Commission of Architectural Review

5. COA-165915-2025	Final Review	Meeting Date: 5/27/2025
Applicant/Petitioner	Bryan Smith	
Project Description	Install a concrete patio on the side of a building and expand window opening to create entrance.	
Project Location		
Address: 1333 East Cary Street		
Historic District: Shockoe Slip		
High-Level Details: The subject building is a three-story commercial building circa 1917. The applicant proposes to alter an existing window on the building's east elevation to accommodate a new door. The new door will serve as access to a proposed concrete patio, which will be located between the side of the building and 14 th Street. Existing curbs and fences will be retained.		
Staff Recommendation	Approval, with Conditions	
Staff Contact	Alex Dandridge, alex.dandridge@rva.gov , (804) 646-6569	
Previous Reviews	None.	
Staff Recommendations	<ul style="list-style-type: none"> Work be done in a way that disturbs as little historic material as possible, and historic features of the building be protected and preserved during construction.

Figure #3 1998 image showing subject windows boarded up.

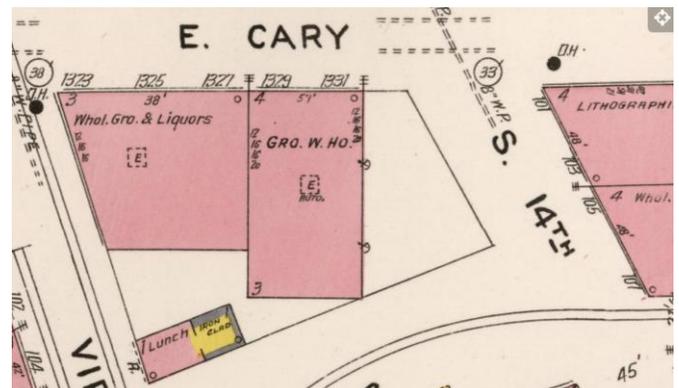
<p><i>will be considered by the Commission on a case-by-case basis.</i></p>	<p>A 1995 & 1998 image demonstrate that the windows on the east elevation have been changed; however, their size has not been altered.</p> <p>The applicant proposes to lower the sill of the left window and drop it to grade to install a new door that will provide access to the proposed patio. The new door will fit within the width of the existing opening.</p> <p>The new door, transom, and sidelight will be aluminum with a black finish. These are modern materials that will differentiate this as a newer alteration to the building. A new concrete landing, step, and handrails on either side of the new entrance will be installed. Staff finds that these are simple elements that will not detract from the overall historic character of the building and how the development of the site is understood.</p>
<p>Sidewalks and Curbs, pg. 76</p>	<p><i>4. Brick or granite pavers are the most appropriate choice in most Old and Historic Districts.</i></p> <p><i>5. Existing granite curbing should be retained whenever possible.</i></p> <p><i>6. Sidewalk design should allow for the installation of appropriate urban landscaping.</i></p> <p><i>7. Sidewalks and curbs should be built of common building materials found throughout the District. Generally, simple paving designs are more compatible with the diverse building styles and better unify the various elements found on streets throughout Old and Historic Districts. The use of more than two paving materials within an area is discouraged.</i></p>	<p>A variety of paving material exist in the immediate area including cobblestone, brick, granite, and concrete.</p> <p>The applicant is proposing to install a non-dyed, concrete patio adjacent to the secondary elevation of the building that will face the corner of E. Cary Street and N. 14th Street. While the guidelines suggest that brick and granite are the most appropriate paving materials, Staff finds that concrete is also an appropriate paving material given its simplicity in design and presence throughout the district.</p>
